UNITED STATES
NUCLEAR REGULATORY COMMISSION
REGION I
631 PARK AVENUE
KING OF PRUSSIA, PENNSYLVANIA 19406

IE Bulletin No. 80-20
Page 1 of 2

FAILURES OF WESTINGHOUSE TYPE W-2 SPRING RETURN TO NEUTRAL CONTROL SWITCHES

FIGURE 1

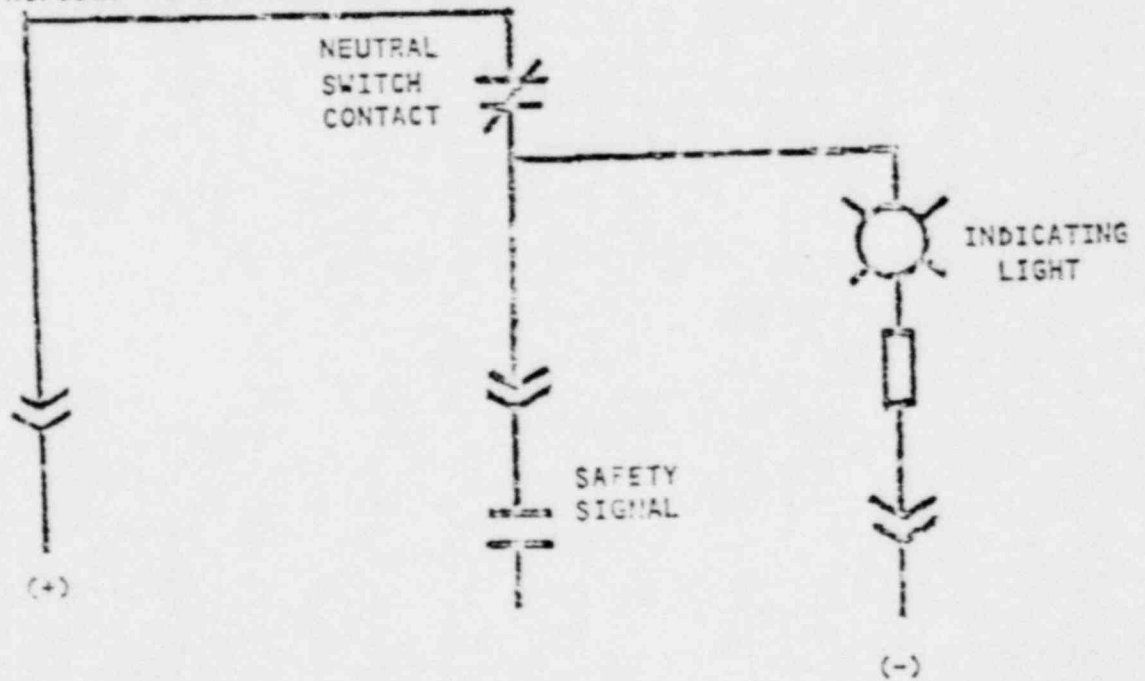
A review of this matter by Westinghouse led to the issuance of NSD Technical Bulletin No. NSD-TB-80-9 to the utility owners of all Westinghouse operating plants. The recommendations contained in the Westinghouse technical bulletin include: (i) testing the neutral position contacts of the subject W-2 switches for continuity, and (ii) rewiring of the indicating light circuit to permit the early detection of a neutral contact failure as shown in Figure 1.

Depending on how the indicating light circuit is wired, loss of continuity thru the neutral position contact of a W-2 switch could remain undetected until the equipment associated with the switch were called upon to operate. Since such a failure would be equivalent to by-passing the system associated with the switch, consideration should be given to rewiring the switches used in safety-related applications as shown in Figure 1. Such rewiring would provide an acceptable means for detecting contact failure, provided the indicating light is in the control room and readily visible by the operator. If the indicating light is not so located, consideration should be given to annunciating the neutral position contact failures at the control room to alert the operator of the inoperable status of a safety-related system. In addition, consideration should be given to adding redundant contacts to the W-2 switches or to replacing the W-2 switches with others having a more positive contact wiping action.

3. Licensees of operating plants and holders of construction permits shall describe the longer term corrective measures planned and the date by which such measures will be implemented by actual installation or by design change, as appropriate. As a minimum, the longer term corrective measures should include rewiring the indicating light as shown in Figure 1 provided the light is readily visible to the control room operator. If not, failures of the neutral position contacts should be annunciated in the control room.

PROPOSED REWIRING OF INDICATING LIGHT CIRCUIT (TYPICAL)

REWIRING OF INDICATING LIGHT CIRCUIT OF W-2 SWITCHES
AS RECOMMENDED BY WESTINGHOUSE TECHNICAL BULLETIN NSD-TB-80-9
